**TECHNICAL SUPPORT DOCUMENT
FOR PREVENTION OF SIGNIFICANT
DETERIORATION (PSD) PERMIT**

PERMIT NO: PSD-11-05

**Puget Sound Energy
Fredonia Power Generating Station**

**January 30, 2013
Revised October 21, 2013**

Figure 1. Hours of Operation for Combustion Turbines, by Year¹⁹

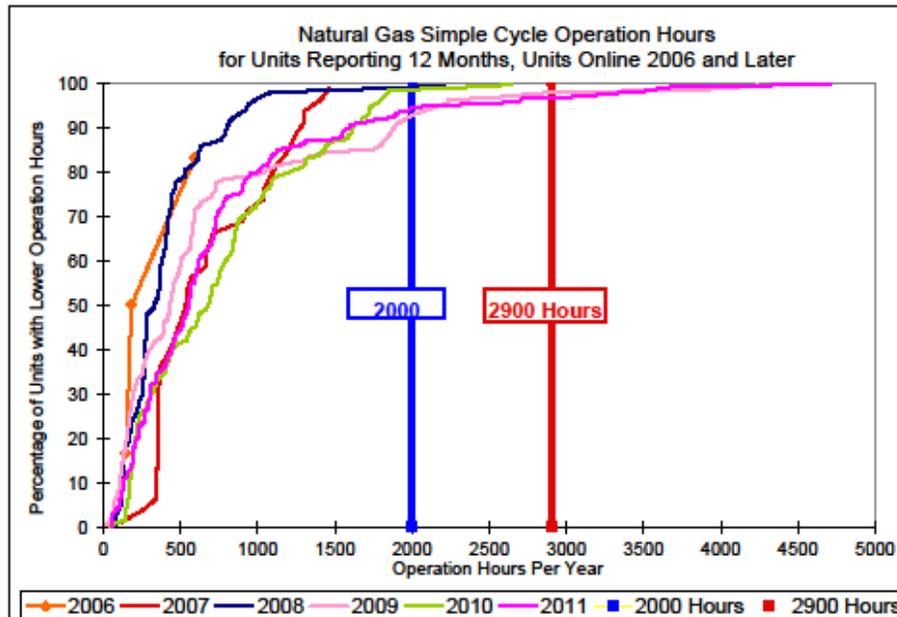
a) Peaking Units Operate Less than 2000 Hours Annually

The TSD states that the Fredonia project must “respond to rapidly changing and often short-term peak power demands on PSE’s system.” (TSD at p.31.) However, the annual operating hours for all of the proposed units are much higher than typical peaking units. The available data show that almost all simple cycle combustion turbine units have low operating hours – but they also appear to show that a few large simple cycle units have high capacity factors. The TSD assumes that the LMS 100 would operate 2,880 hours per year excluding startup and shutdown, while the remaining units would operate 2,280 hours per year. (TSD at p.5.) This equates to capacity factors of 33% and 26%, respectively. The histogram in Figure 1 shows that the annual operating hours in the proposed permit are too high. The “knee in the curve” for these data appears to be below 2000 hours for 2011 (the most favorable¹⁸ year for industry), thus showing that operation greater than 2000 hours is not consistent with the normal operation of simple cycle units.

These data suggest that an hour of operation assumption above 2,000 hours does not sufficiently differentiate peaking from intermediate-load units. Intermediate units may operate seasonally, but for many hours at a time once started up. Such intermediate units are seasonal or load following, and these units are not true peaking units. In the proposed permit, Ecology must set the operational hours (and corresponding fuel limits) based on the characteristics of a peaking unit because it expressly rejected consideration of combined cycle units on the grounds that PSE needed the Fredonia project for “peaking applications.” (TSD at p.31.) If PSE plans to operate Fredonia as an intermediate resource rather than a peaking resource, then the BACT analysis must fully consider combined cycle units as a feasible alternative.

Figure 2. Hours of Operation for Combined Cycle Units

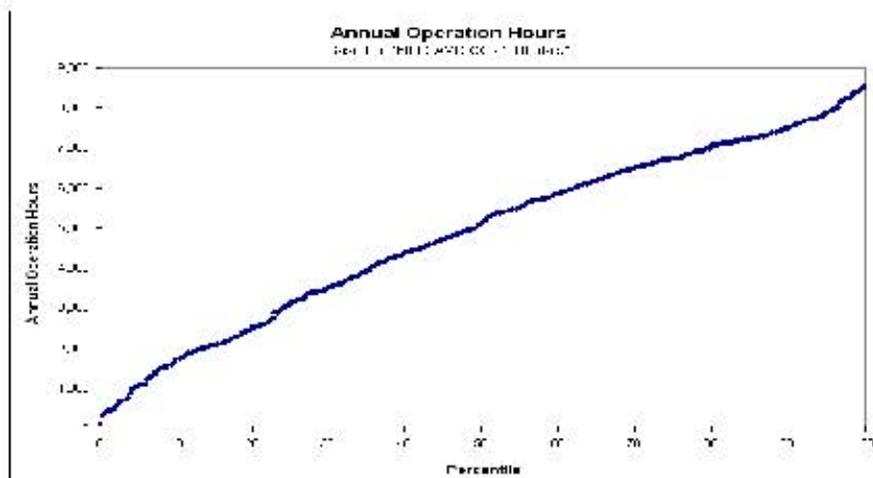
We note that even 2000 hours of operation may represent simple cycle units that are in intermediate load rather than peaking operation, especially if such use is seasonal. We also note that there are a substantial number of combined cycle units that are designed for intermediate load applications but that may have limited hours of operation because of market conditions. Eighty-two of the 592 recently constructed combined cycle units in the EPA CAMD data set, Figure 2, operate less than 2000 hours per year; 143 of those units operated less than 2900 hours per year.
